DATE: April 9, 2009

Addenda No. 2

SUBJECT: US20: Bulger Cr – Riley Jct. Section
Central Oregon Highway
Harney County
Paving Project
(Bids to be opened and read April 16, 2009)

SHEET NO. **2B-2**

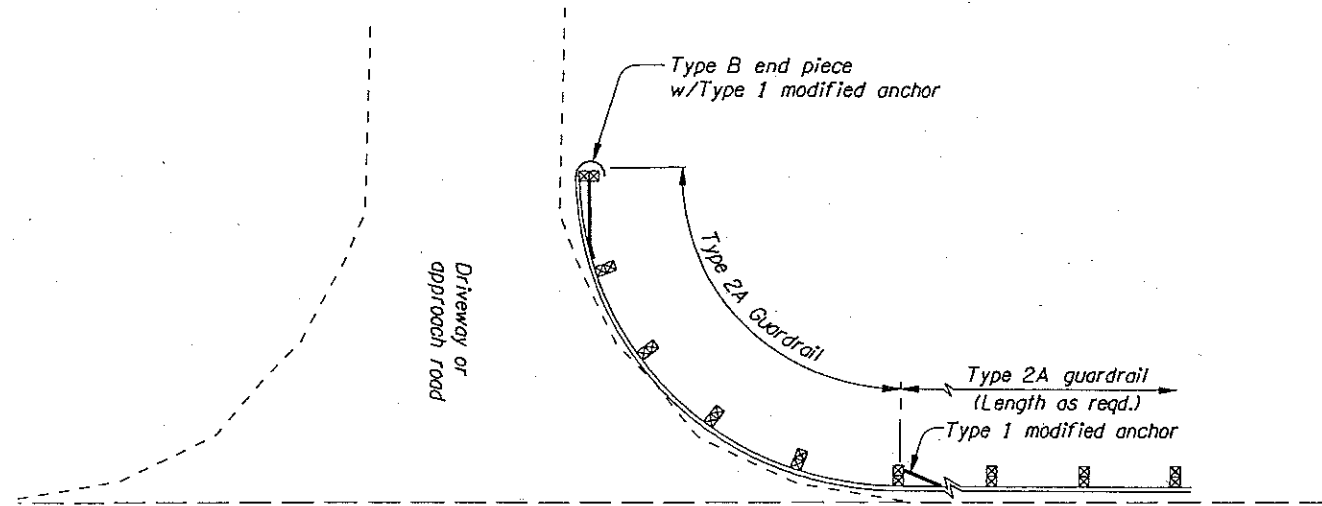
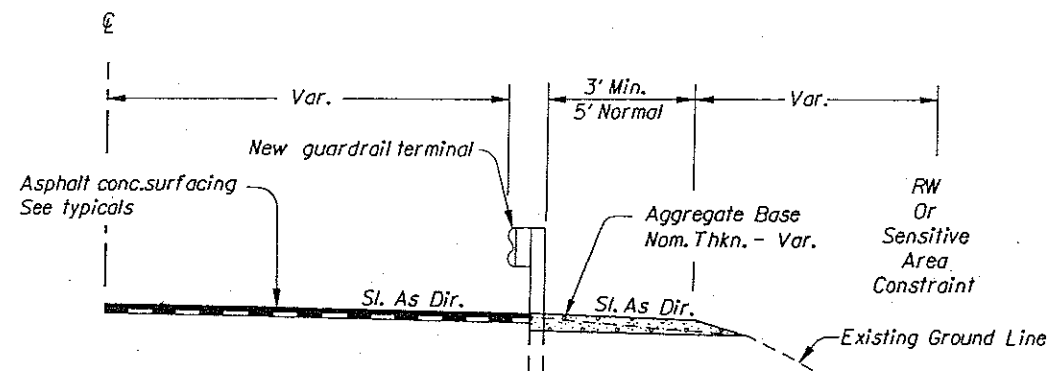
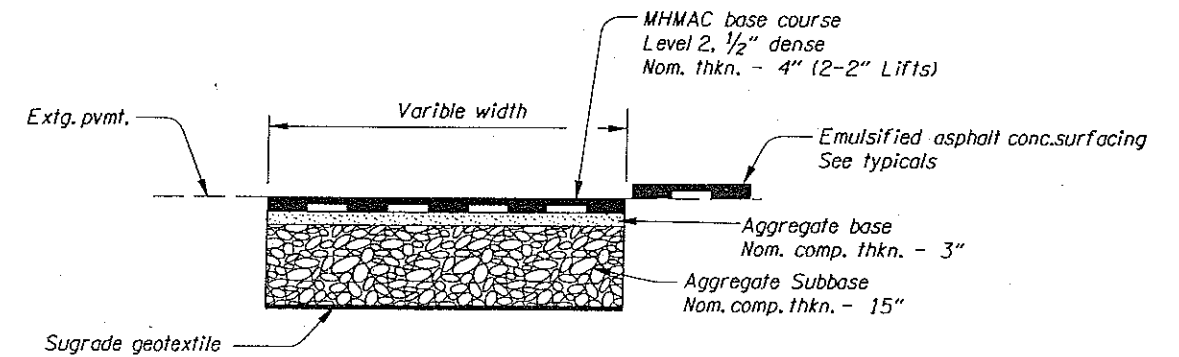
REVISIONS	
1	4/9/2009 Modified Approaches List
2	4/9/2009 Change sheet no. from 2A-2 to 2B-2
